September 2, 2026

RE: Eastwoods Drive Roadway Improvement and Extension
Applicant: Zena Development, LLC
Property: Eastwoods Drive (38.2-1-43, 38.2-1-44 & 38.2-1-38.100)

July 31, 2026

**Re: Zena Development, LLC
Ruby Woods (off Eastwoods Drive)**

Please refer to attached for the gravel surface detail included in the Zena Homes Subdivision plans.

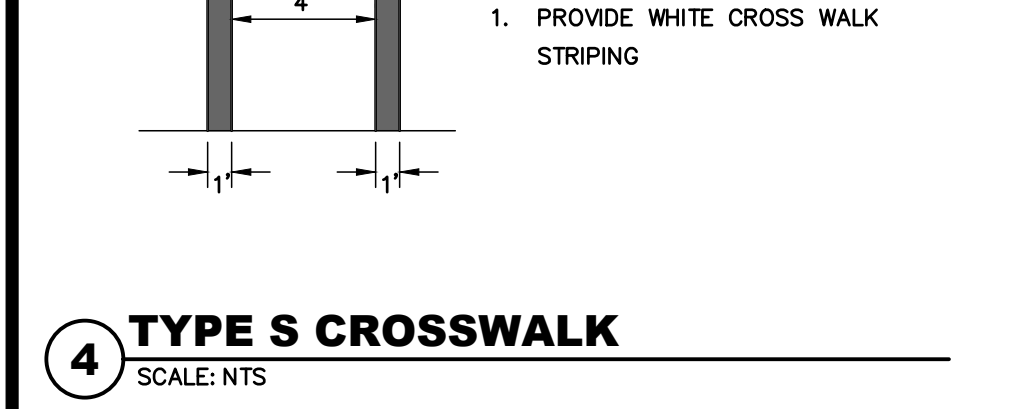
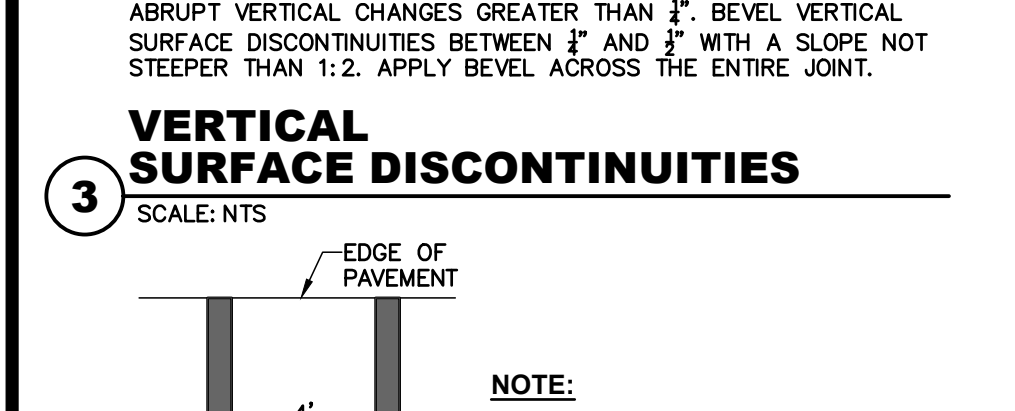
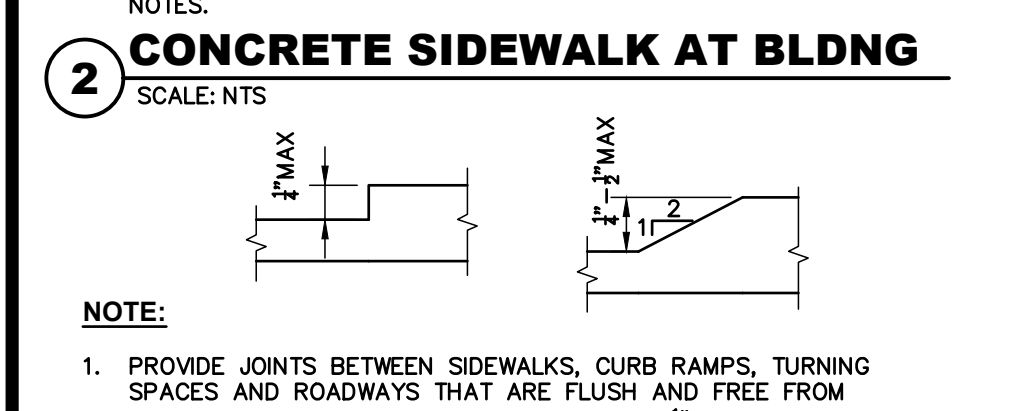
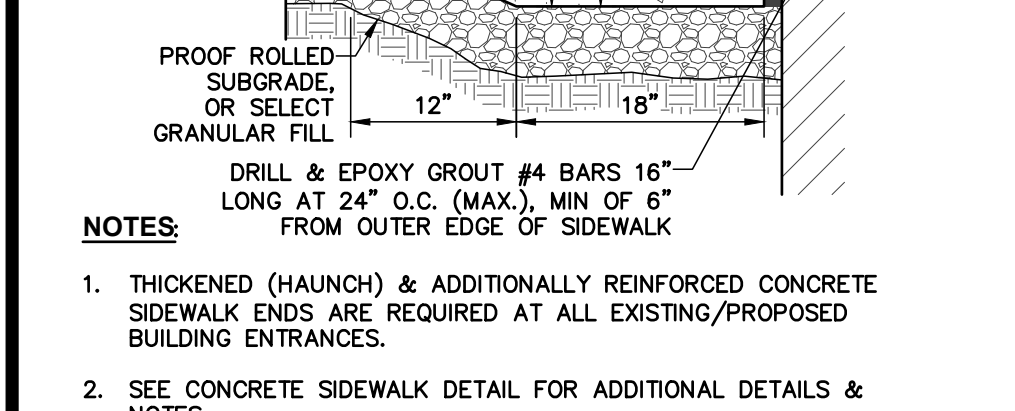
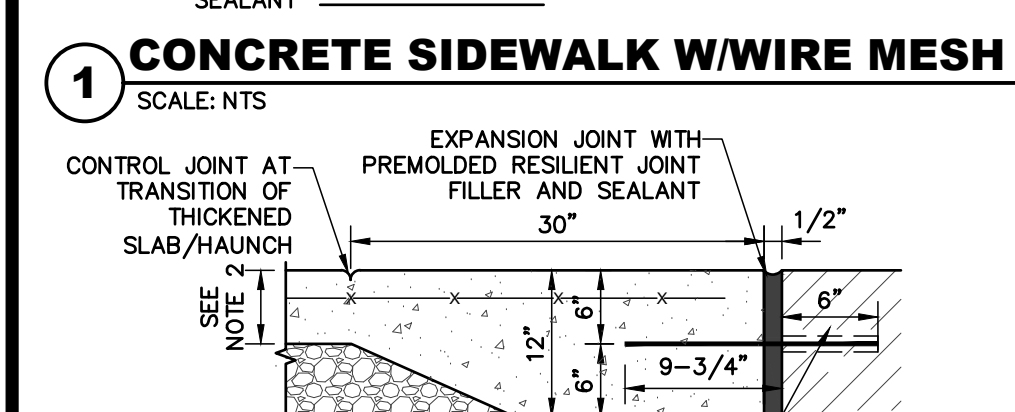
The comment letter raises the question of whether the existing roadway base can support temporary construction activities and increased long-term traffic volumes. The Applicant agrees that the existing gravel depth is deficient relative to Town (Woodstock) standards and, for that reason, the project proposes remediation of the existing roadway section. To bring Eastwoods Drive into compliance with the "Major Road" design standards of § 202-32 G (19) and § 202-32 G (4) Appendix B which include 12-inches of "compacted approved quarry rubble, creek gravel, or R.O.B. gravel" and 6-inches of "compacted approved gravel, item 4, or 400 fines", pavement cores will be taken to determine the existing materials used and their depths. This will also determine the amount of material that needs to be installed. Any core samples taken will occur prior to construction. This remediation is intended to address any long-term maintenance or deterioration of material concerns.

WOODSTOCK WETLAND AND WATERCOURSE PERMIT MITIGATION FIGURE

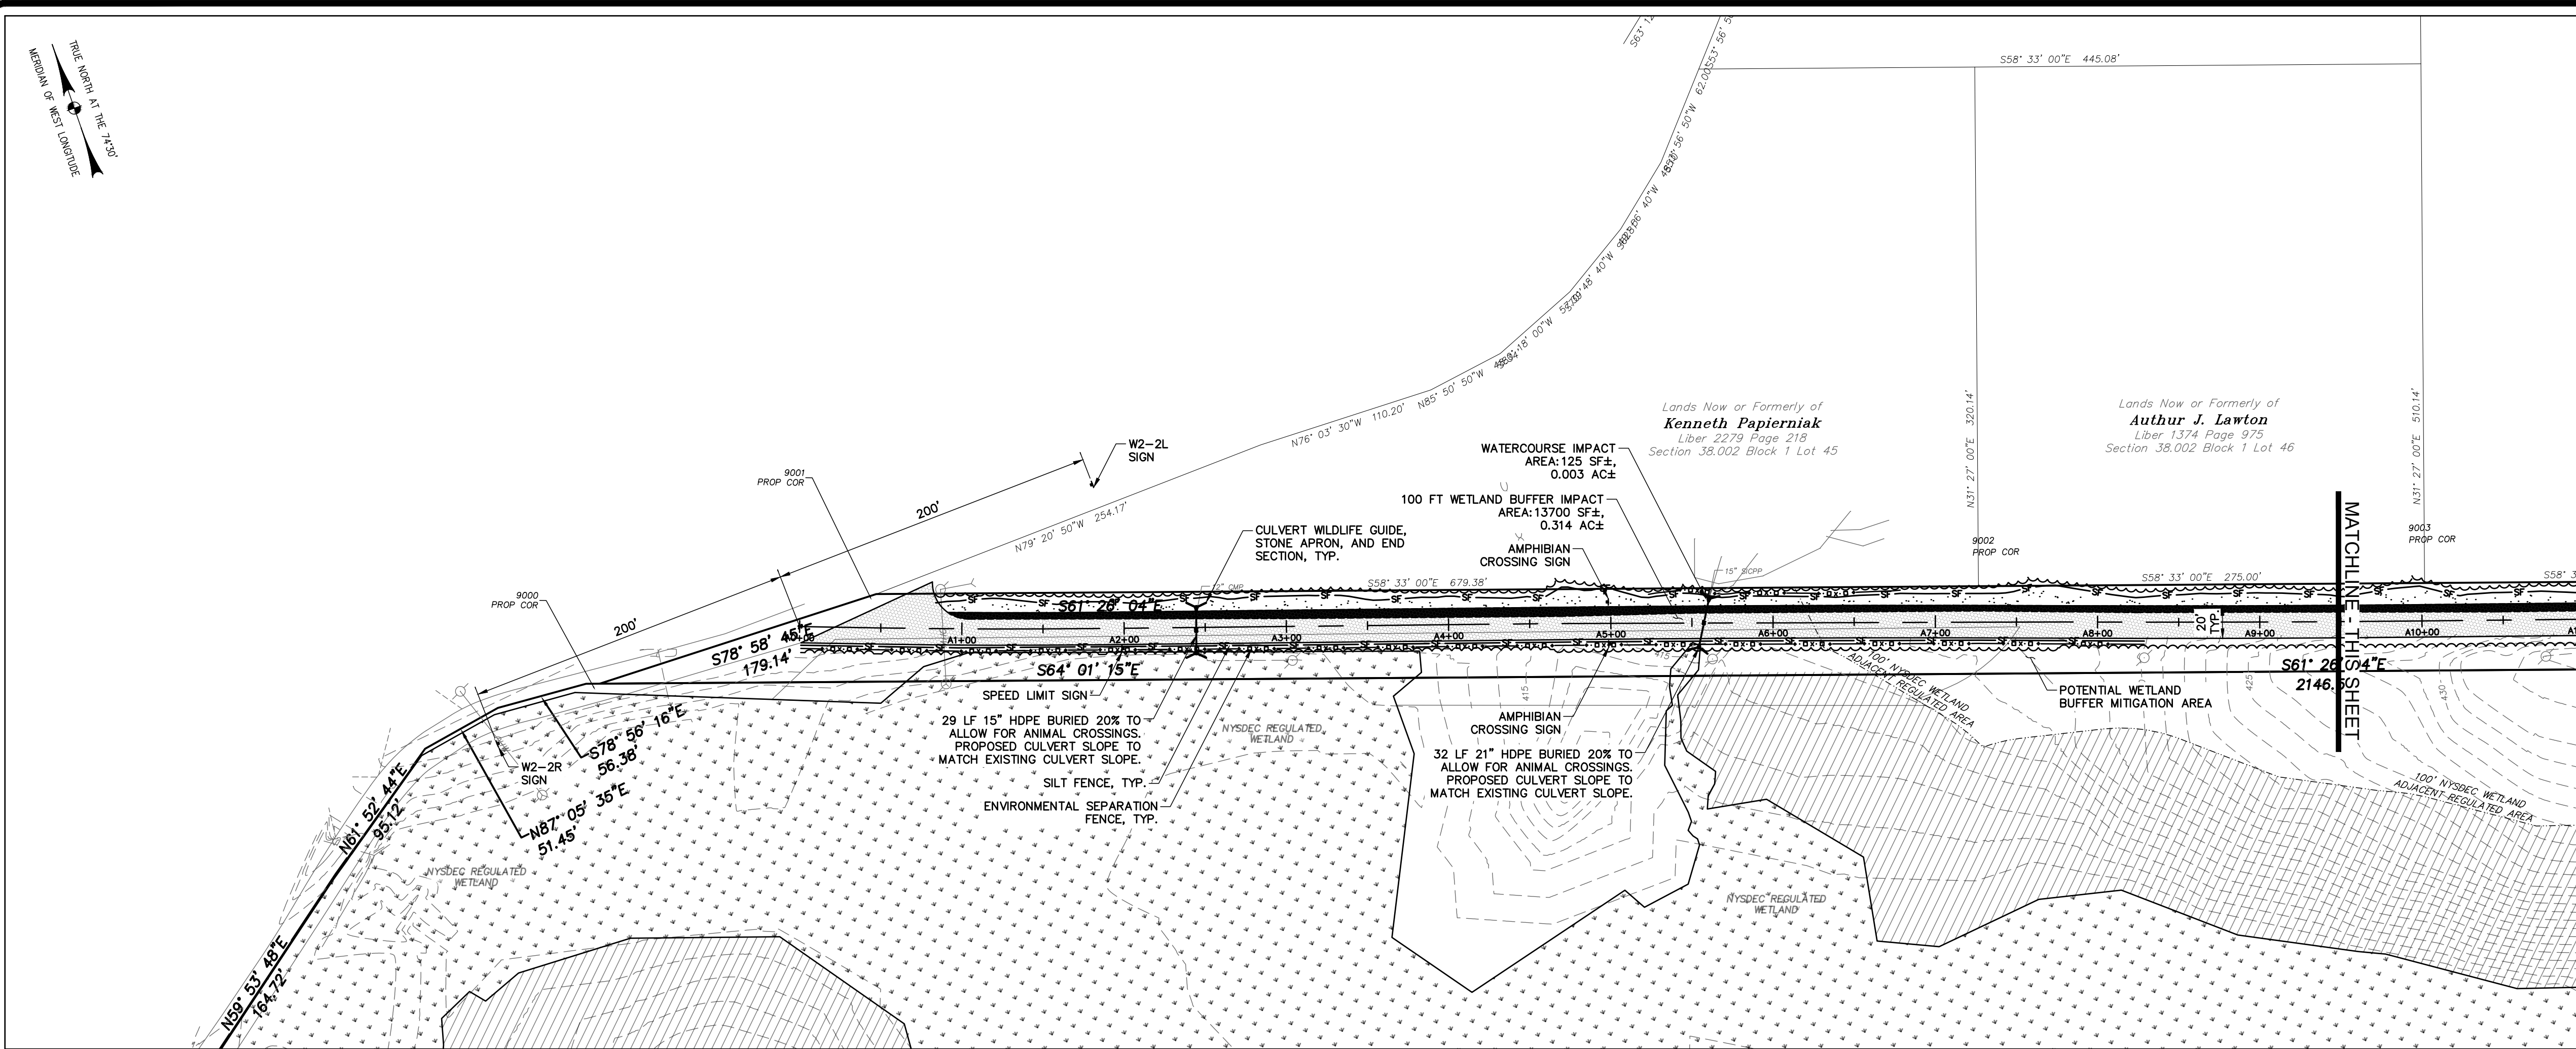
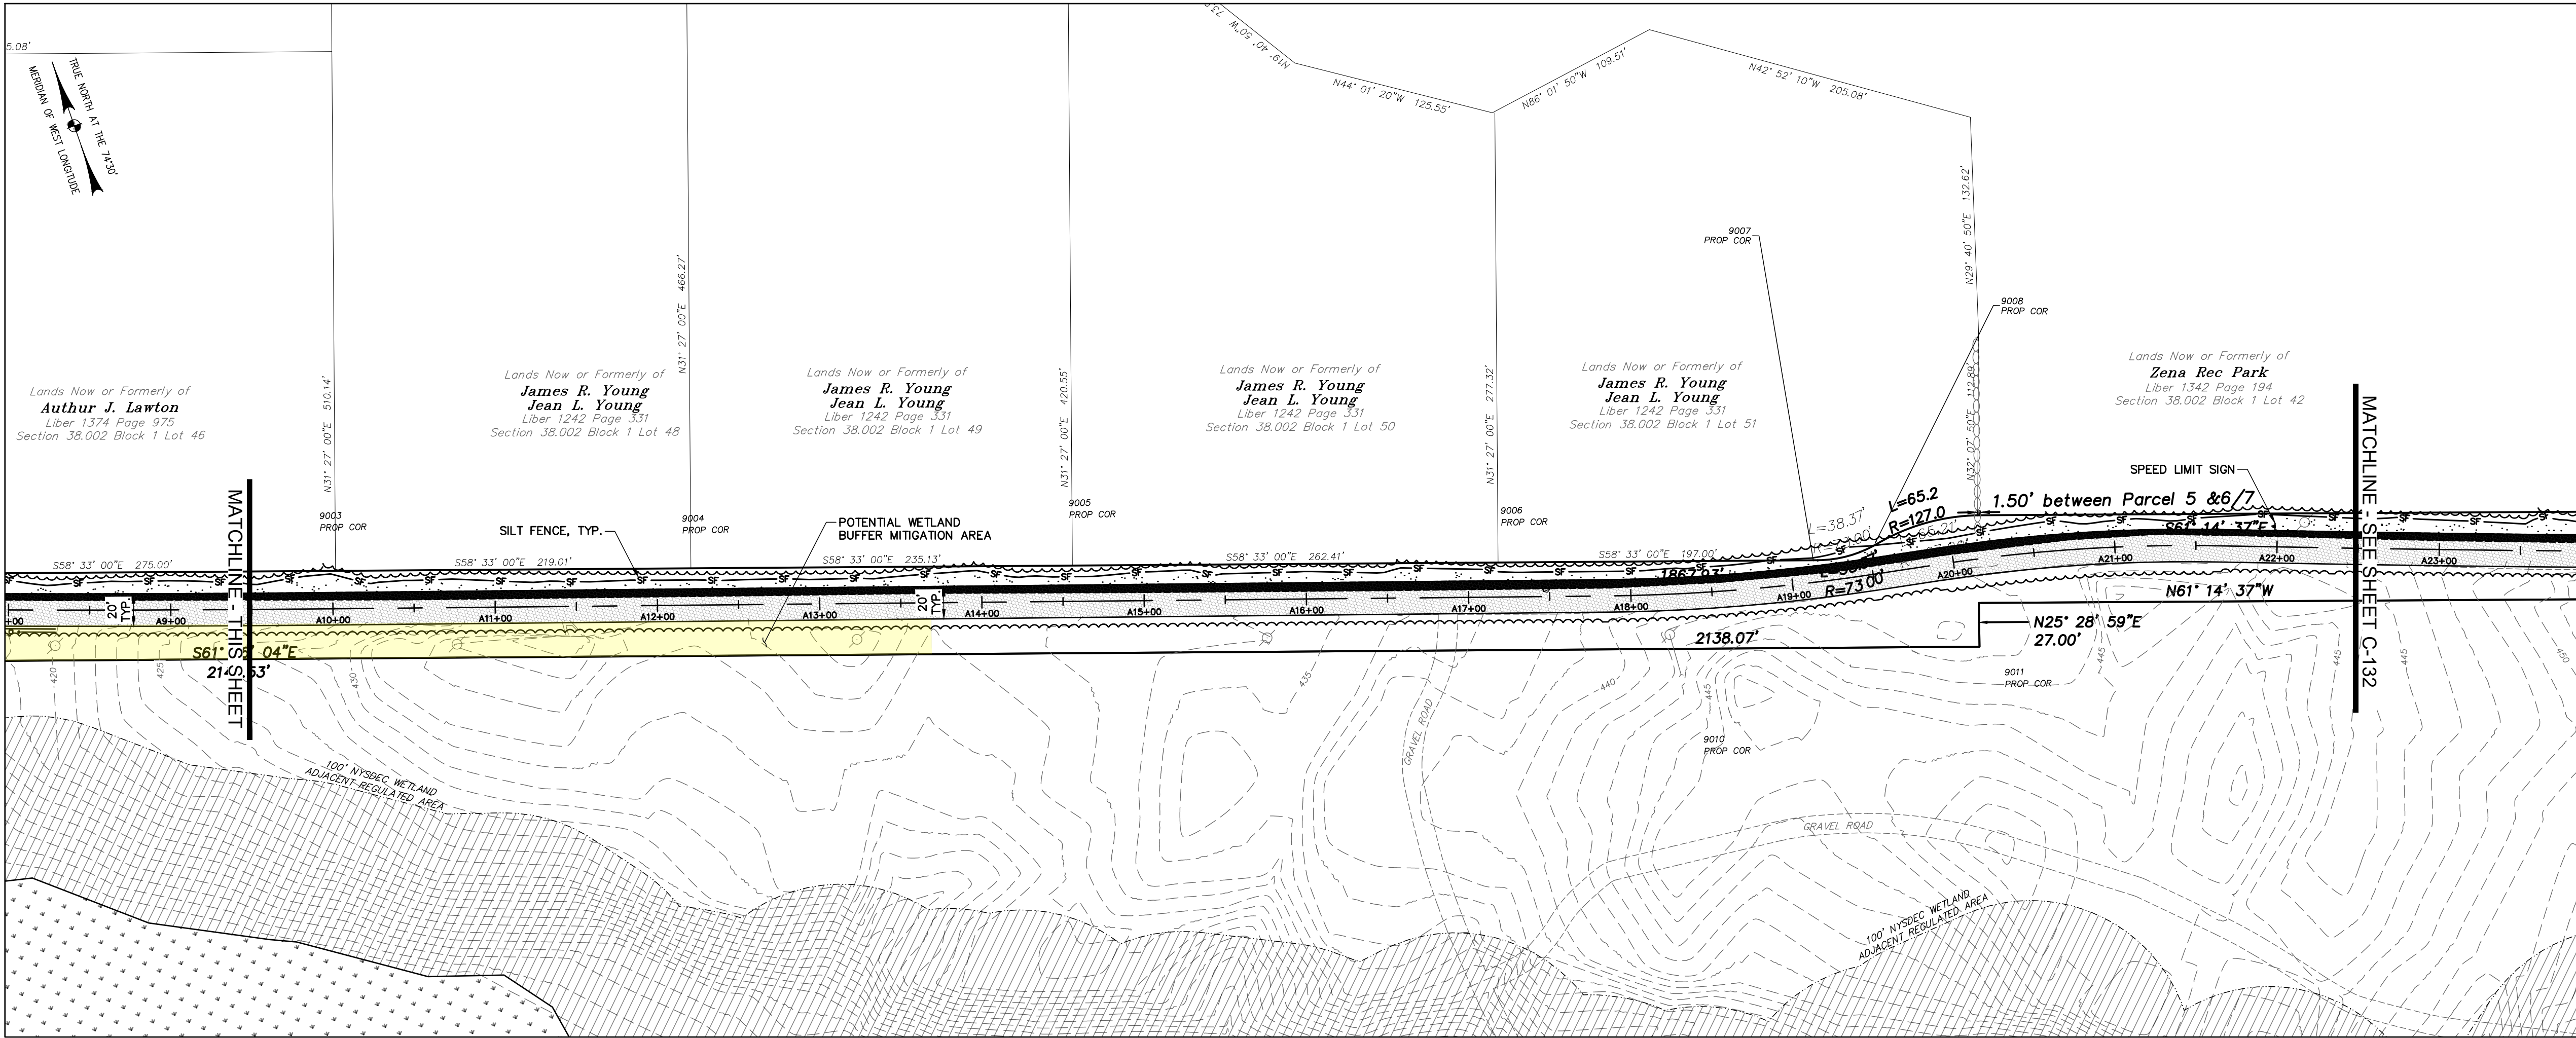
The Applicant's last appearance before the Planning Board was on November 6, 2025. At that meeting, the Board requested and the Applicant has since incorporated the following additional mitigations into the Wetland and Watercourse Mitigation figures:

1. Orange construction fencing around wetlands to prevent intrusion during roadway construction;
2. Little bluestem has been added to planting plan;
3. Culvert Wildlife Guides have been added to direct amphibians to the culverts;
4. The proposed seed mix for the wetland buffer restoration areas is to be approved by the Town;
5. A culvert and wildlife guides have been added to the portion of the road extension area approximately 60 meters from Wetland DM-7; and
6. A proposed intersection sign per traffic study has been incorporated.
